June 29, 2016

Subject: Response to the Lancaster (2015) Study Regarding Movement of Gravel and Other Coarse Material by Wind at Shell Guadalupe Dunes Gravel Remediation Project Site

Prevailing Wind Direction and Gravel Movement Direction FIGURE 2

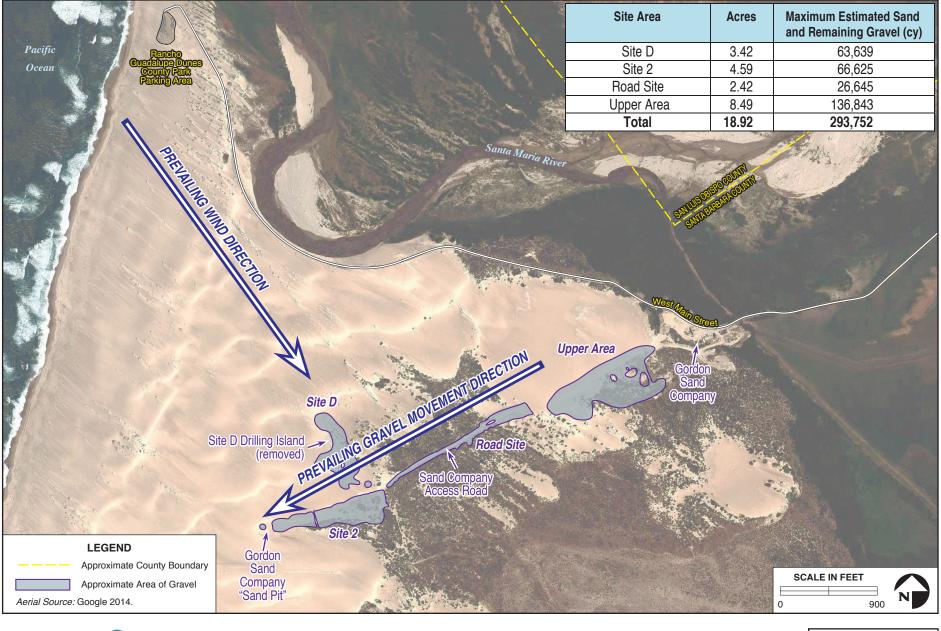
As requested, I have reviewed the report prepared by Nicholas Lancaster, PhD on behalf of Hollister & Brace, the attorneys for the Gordon Sand Company. Although the report is entitled, "Movement of Gravel and Other Coarse Material by Wind at the Shell Guadalupe Dunes Gravel Remediation Project Site", the discussion in the report regarding wind transport of sediments focuses primarily on sand-size particles. Referenced materials in the report are used to present a potential mechanism for wind transport of particle sizes up to 3 millimeters (mm), which can be classified as sand or gravel depending on the classification system that is used (Unified Soil Classification System: maximum sand particle size = 4.75 mm; Wentworth Scale: maximum sand particle size = 2 mm). More importantly, the report provides no discussion of the prevailing wind direction at the site, which is the primary mechanism for transport and sorting of the sand that comprises the Guadalupe Dunes. The effects and direction of the west-northwest (WNW) prevailing winds are clearly visible in the linear shape of vegetation and other surface features shown on the attached Figure 2. The possible wind transport mechanism briefly outlined in the report suggests that transport [and associated sorting] of particle sizes up to 3 mm (coarse sand or very fine gravel) could potentially occur from the existing imported gravel and cobble deposits. However, photographs of the imported gravel deposits included in the report show no apparent evidence of any significant transport or sorting of these materials in any direction from the relatively discreet localized deposits shown in the photos. There are no known natural processes at the Project site that would account for transport of gravel and cobbles (e.g., up to 6inches in diameter) in a southwesterly direction and any apparent movement of those materials in that direction (i.e., near perpendicular to the prevailing wind direction) must be manmade or anthropologically influenced.

A secondary gravity mechanism is suggested in the report for possible transport of particle sizes larger than 3 mm (i.e., larger than coarse sand [USCS] or very fine gravel [WS]). As described in the report, this would occur due to undermining of the larger clasts by wind erosion of the surrounding sand and ultimately possible gravity movement down any slopes created by the wind erosion. The information in the report essentially describes a potential mechanism for localized incremental dispersion of the particles, but not significant transport (e.g., up to and exceeding 500

feet). This conclusion is consistent with the localized concentration of the imported gravel deposits shown in the photographs included in the report.
